UN#10-062

Subject: UniStar Nuclear Energy, NRC Docket No. 52-016  
Response to Request for Additional Information for the  
Calvert Cliffs Nuclear Power Plant, Unit 3,  
RAI No. 182, System Quality Group Classification

**Response to NRC Request for Additional Information  
RAI No. 182, Questions 03.02.02-1 and 03.02.02-3 through 03.02.02-6,  
System Quality Group Classification,  
Calvert Cliffs Nuclear Power Plant, Unit 3**

### Replacement for FSAR Figure 9.2-3, Normal Makeup, Emergency Makeup, Blowdown & Chemical Treatment

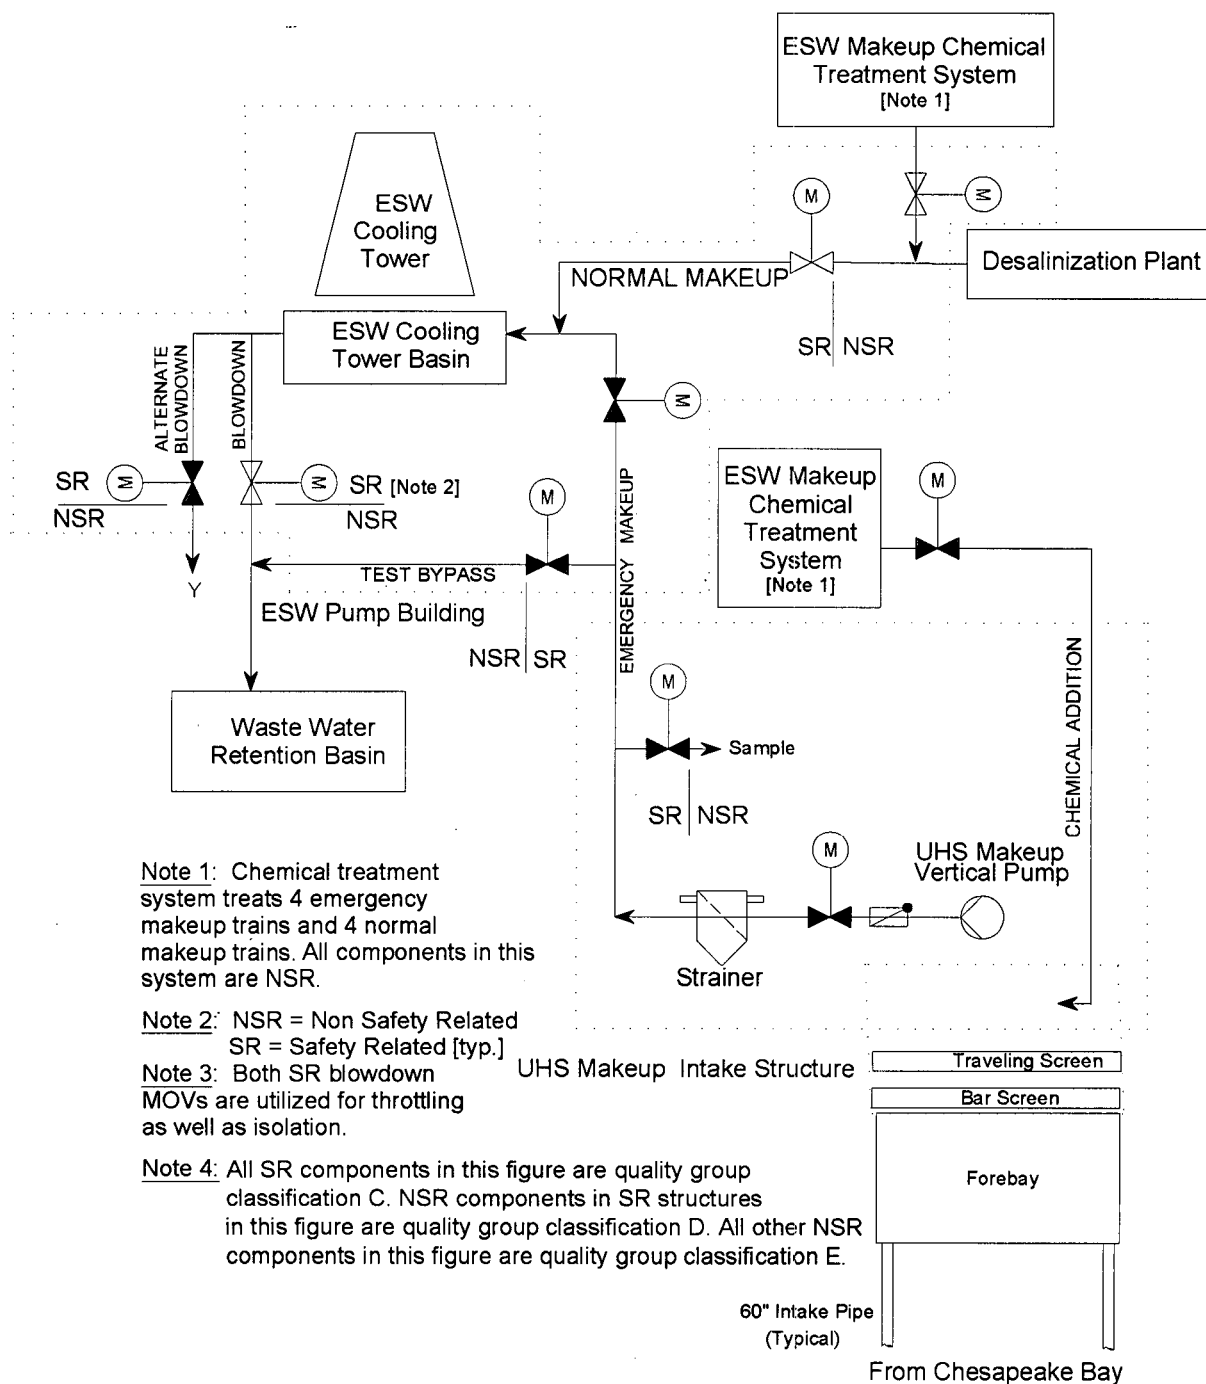
SRP 3.2.2 calls for review of the piping and instrumentation diagrams (P&IDs) to ensure that the applicant delineated the system quality group classification boundaries for systems important to safety. Drawings available in the FSAR, such as Figure 9.2-3 for the UHS makeup, do not show the system quality group classifications and appear to be conceptual. Clarify the quality group classifications on these figures and identify when the detailed P&IDs will be available for review.

The Raw Water System and the UHS Makeup Water System are the only site-specific systems that are either important to safety or interface with systems important to safety. FSAR Figure 9.2-3, Normal Makeup, Emergency Makeup, Blowdown & Chemical Treatment, will be updated to include appropriate quality group classification. Detailed P&IDs of systems important to safety are currently scheduled to be available in 4<sup>th</sup> Quarter of 2012.

FSAR Figure 9.2-3 updates associated with the response to this question are included with the COLA impacts associated with the response to RAI 182, Question 03.02.02-01 (this enclosure).
